SUBJECT: SEQUOYAH NUCLEAR PLANT, UNITS 1 AND 2 - ISSUANCE OF
AMENDMENTS REGARDING INCREASED TEMPERATURE AND LEVEL
LIMITS OF ULTIMATE HEAT SINK (TAC NOS. MD2621 AND MD2622)

The amendments revise the technical specifications to establish the minimum water level of the ultimate heat sink (UHS) as 674 feet and to increase the temperature limit of the essential raw cooling water (ERCW) system from 84.5 degrees Fahrenheit (°F) to 87 °F.

SAFETY EVALUATION BY THE OFFICE OF NUCLEAR REACTOR REGULATION
RELATED TO AMENDMENT NO. 317 TO FACILITY OPERATING LICENSE NO. DPR-77
AND AMENDMENT NO. 307 TO FACILITY OPERATING LICENSE NO. DPR-79
TENNESSEE VALLEY AUTHORITY
SEQUOYAH NUCLEAR PLANT, UNITS 1 AND 2
DOCKET NOS. 50-327 AND 50-328

Figure 1. Annual minimum headwater levels (ft-msl) in the Chickamauga Dam (from the licensee, Ref. 3).

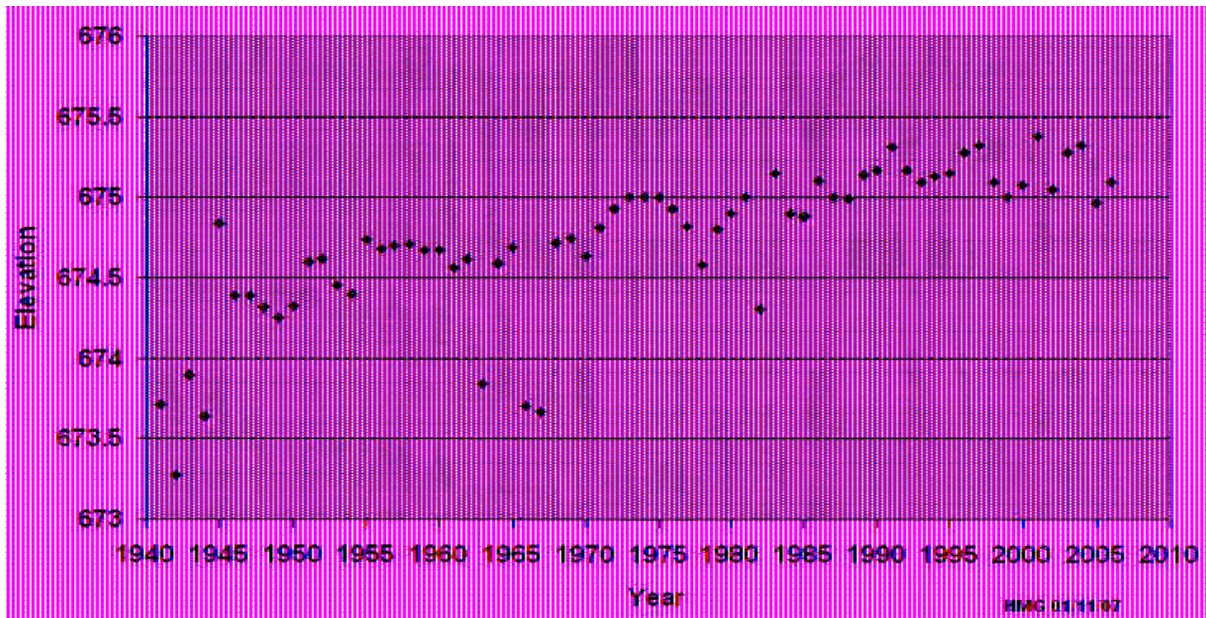
Referring to the attached figures, Figure 1 demonstrates that long-term annual minimum water levels have increased consistently due to the increasing of minimum upstream releases with the revised water control policies in the river. Figure 2 shows that reservoir levels have not dropped below 675 ft-msl since 2000, even during the dry season. Figure 3 shows that initial water levels greater than 675 ft-msl induce a milder recession rate than that for an initial level of 674 ft-msl. After the steep recession during the first 2 hours, the recession rates with the initial level above 675 ft-msl are about 1 foot per hour. In other words, the recession rates with initial water levels above 675 ft-msl automatically may meet the 4-hour-above-670-foot limiting condition.

Figure 3. Chickamauga Reservoir recession curves simulated by the SOCH model with different initial reservoir levels, using a breach width of 1000-ft, an initial reservoir level of 630 ft-msl, and a Watts Bar release of 14,000 cfs.

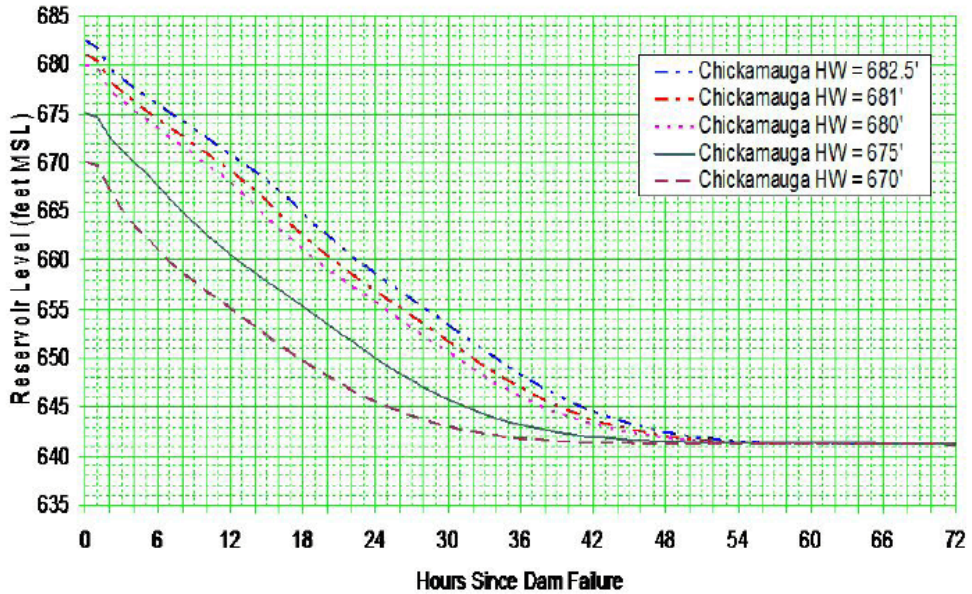
Instead, the staff evaluated breach widths and times using the same four equations as the licensee did but with an initial reservoir level of 675 ft-msl (Table 1). The reason for estimating breach times is to investigate the margin in the reservoir recession rates. The table also includes elapsed times from 674 ft-msl to 670 ft-msl for the estimated breach width equations. The elapsed times were computed based on a relationship between breach width and elapsed time given in Figure 4 (attached), which was constructed by the licensee's reservoir recession rates simulated with the SOCH model.
